**Proposal: Paragraph 6.4.1. and Annex 2  
(online input for EVE-48) – rev.2**

## UN GTR for In-Vehicle-Battery Durability

Online input for EVE-48 in context of Annex 2 (“Monitor Flag”) – Update of paragraph 6.4.1.

## Online input for EVE-48 in context of Annex 2 (“Monitor Flag”) – Flow chart in case of no indicator update

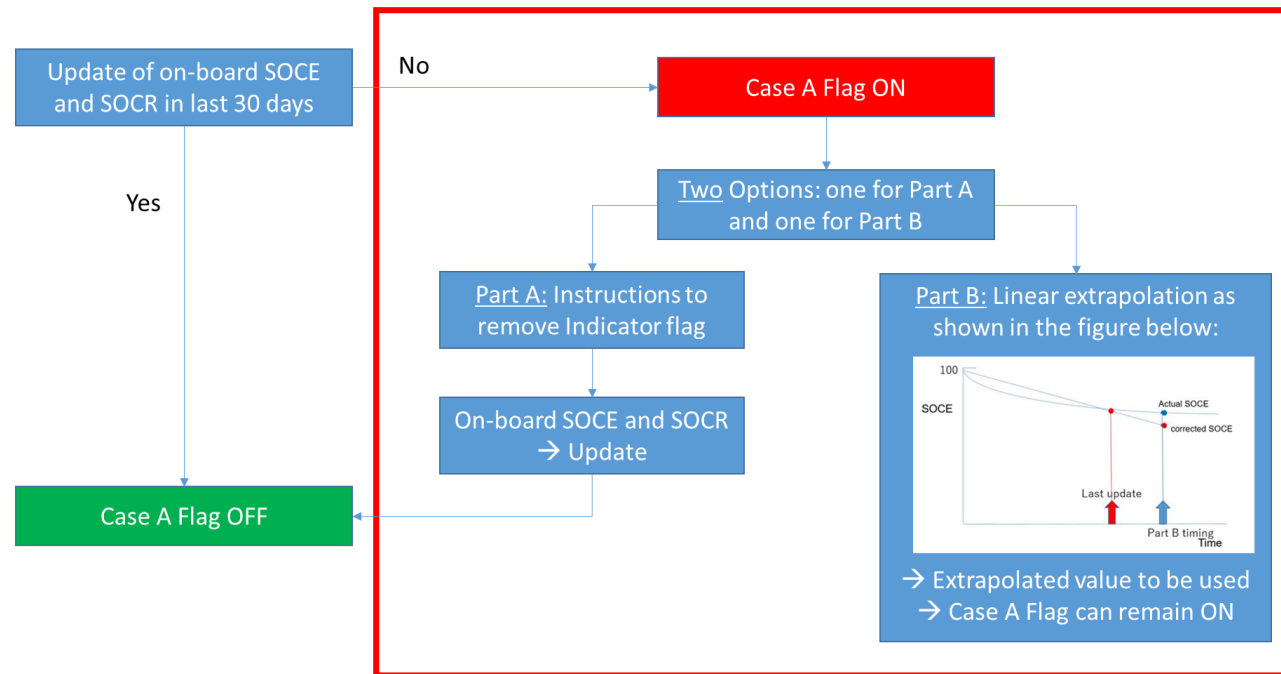
Proceeding for Part A and Part B in case of Case A Flag ON:

**Part A:** In cases where the either monitor is reporting a flag for not being able to monitor accurately according to Annex 2, Cases A, then these vehicles shall be corrected, according to the instructions of the manufacturer, until the flag disappears and then tested. The manufacturer shall provide instructions on what is required to make the monitor able to provide an accurate value.

**Part B:** In cases where the either monitor is reporting a flag for not being able to monitor accurately according to Annex 2 Cases A, the manufacturer shall do a linear extrapolation based on the monitor value of 100% and the latest updated on-board SOCE and SOCR value. The extrapolation shall be done time based and the extrapolated on-board SOCE and SOCR value shall be considered in Part B verification.
